**Town of Rotterdam
Planning Commission
October 7, 2025**

Agenda (V. Dalton Bambury Hearing Room 2nd Floor) – 7:30 pm

2. **Lecce Senior Living Phase II – 2200 Helderberg Avenue/Helderberg Avenue.** Final Site Plan review for the construction of Phase II of Whispering Pines Senior Living consisting of 119 independent living units, 108 memory care units and 144 assisted living units on a 13.71-acre parcel. Engineer: Steenburgh Consulting Engineering, PLLC.

Please find attached to this letter and electronic copy of the revised plans, SWPPP and NOI for the Whispering Pines Senior Project. The plans have been updated to address the TDE comments from CHA for the Whispering Pines Senior Housing Project dated September 4, 2025.

1 SITE PLAN
 SCALE: 1/8\"/>

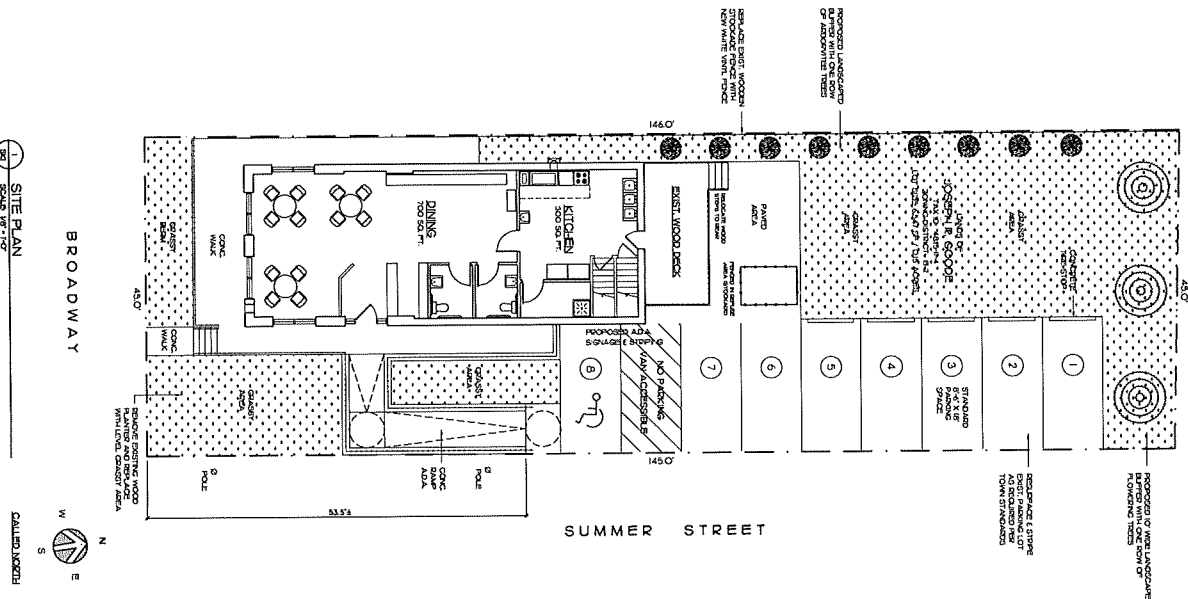
1. Replace silt fence detail with a filter sock and show location.
 2. Change note from City Standard Details to Town Standard Details in title box.
 3. Provide signature block: “Chairman, Rotterdam Planning Commission:
Date: _____”.

4. Change asphalt paving detail to Type 2 stone.
 5. Parking lot shall be patched, repaired, seal coated, and striped prior to the issuance of a Certificate of Occupancy.

1. The parking lot was redesigned and additional on-site parking spaces were added to the updated plans. On-site parking increased from six (6) spaces to eight (8) spaces, including one (1) accessible parking space with ADA striping, with the closest space to the street corner over 53' away. This was achieved by reducing the rear landscaped buffer from 15' to 10' and redesigning the accessible ramp to the building.

2. The existing wooden planter box has been removed from the corner of Broadway and Summer Street and replaced with grass and street trees.
3. A note was added to remove the existing asphalt at various locations and plant grass. In addition, several street trees were added along the frontages of Broadway and Summer Street.

4. A note was added to remove the existing wooden stockade fence and replace in kind with a new white vinyl stockade fence.
5. A pole light was added in the grassy area behind the parking lot near parking space #5 that will meet the town's lighting standards to light the parking lot. Existing under canopy recessed lighting is currently present on the building and will be used and maintained.
